IREDELL COUNTY HEALTH DEPARTMENT

IMPROVEMENT PERMIT / AUTHORIZATION TO CONSTRUCT / OPERATION PERMIT / EXISTING SYSTEM INSPECTION

PERMIT# 136823 PIN# 4664678995,074 4664-67-5657 DATE 9-7-07

SUBDIVISION Amiston BLOCK / SECTION 2 LOT 74 LOT AREA 1.9 Ac SITE CLASS. PS DESIGN FLOW 480gpd L.T.A.R. .25 gpd/ft²

INITIAL SITE SKETCH

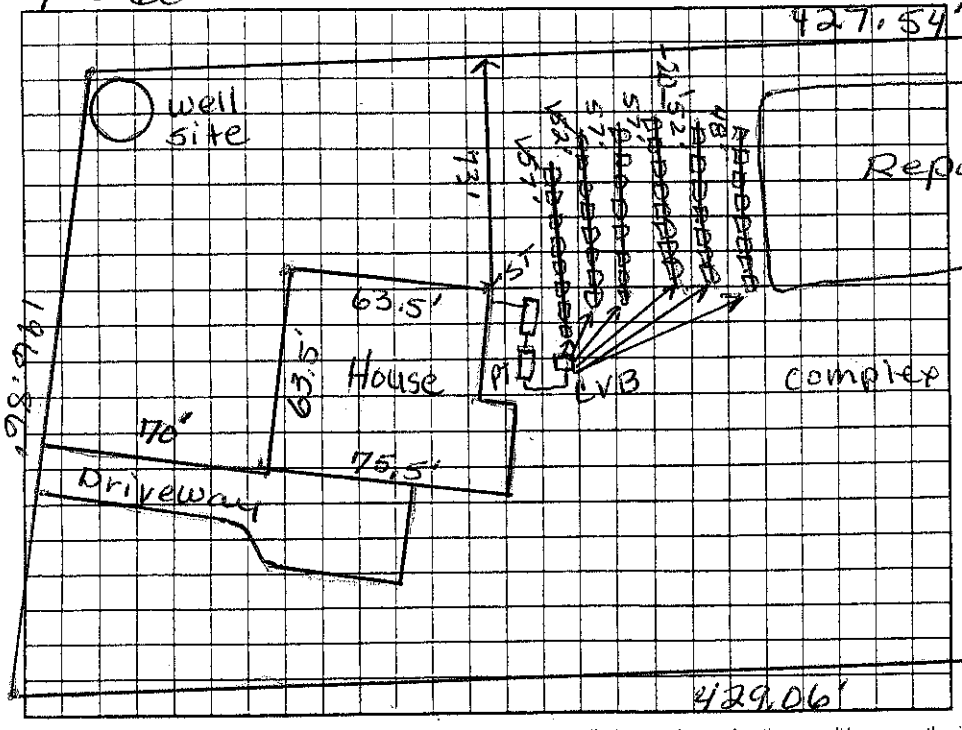
Comments:/Conditions: Redraw based on plan from Rollans Soil & Environmental Services
& per plan specs
Tank to be placed no deeper than 3' below finished grade

AS BUILT SKETCH

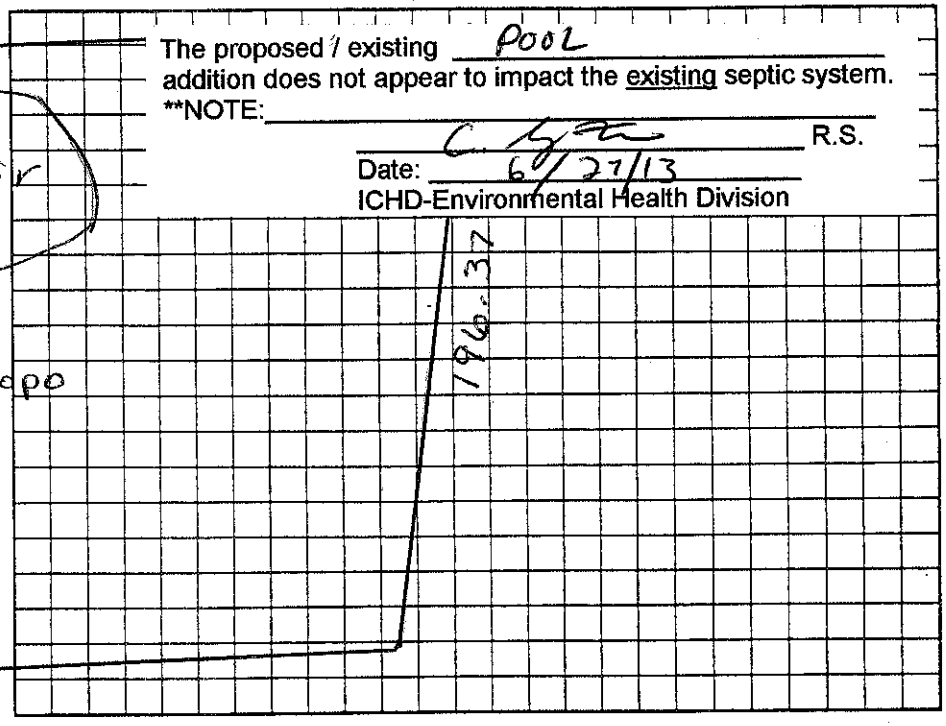
Comments:/Conditions: 3' Ditches - 5/32" ho Lam
House drawn as staked
Pressure set 11/13/07 AC

The proposed / existing pool addition does not appear to impact the existing septic system.
**NOTE:
